Technical Service Bulletin

Bulletin #: CMP-2007-005

Product: Compressor Generator Tools Light Tower

Subject: 7/20 battery wire protection kit CPN23167299

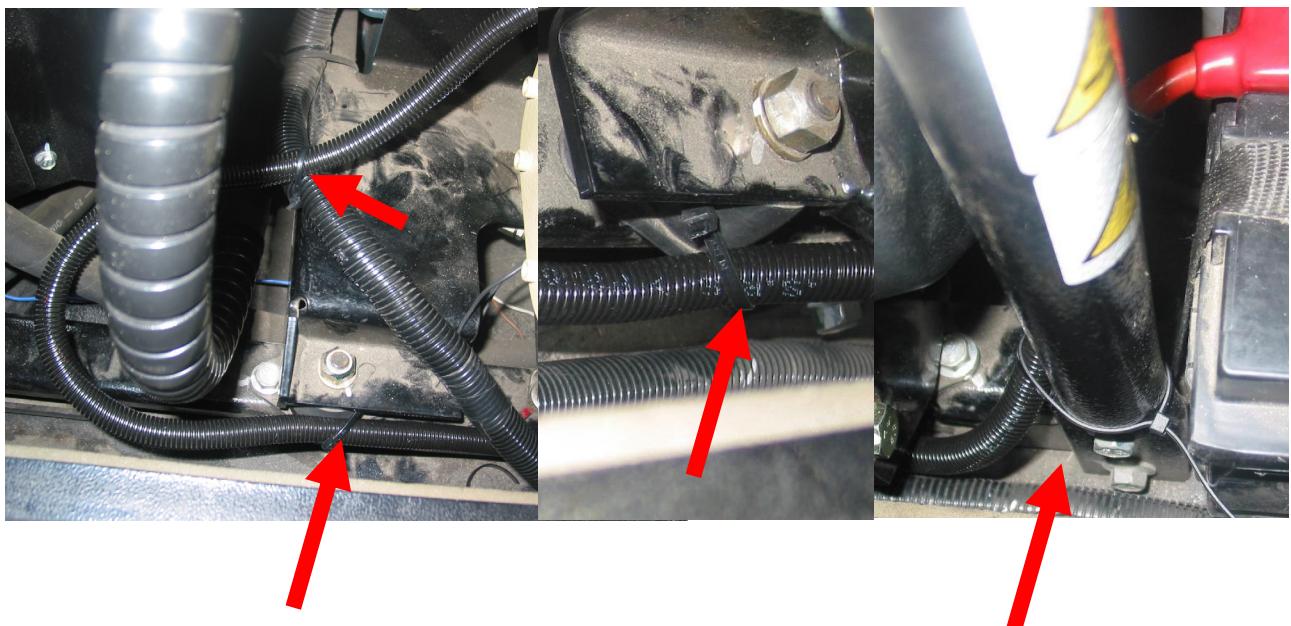
On the above machine the battery positive wire is allowed to lie down on the compressor base. Due to the vibration and dirt this could lead to the progressive wear of the insulation and a potential short cut. A wire protection kit **CPN23167299** was created to solve this issue on the compressors before SN121820. It contains the following parts:

- split conduit to protect the battery wire;
- wire ties to improve the wire support.

Every machine needs to have its battery positive wire inspected at the next service. If the wire presents some wear the kit needs to be fitted.

The kit can be easily fitted in around 10 minutes following the instructions below:

1. Disconnect the battery positive wire from the battery terminal.
2. Fit the split conduit above the wire.
3. Tie the wire as per pictures below.
4. Reconnect the battery positive wire.
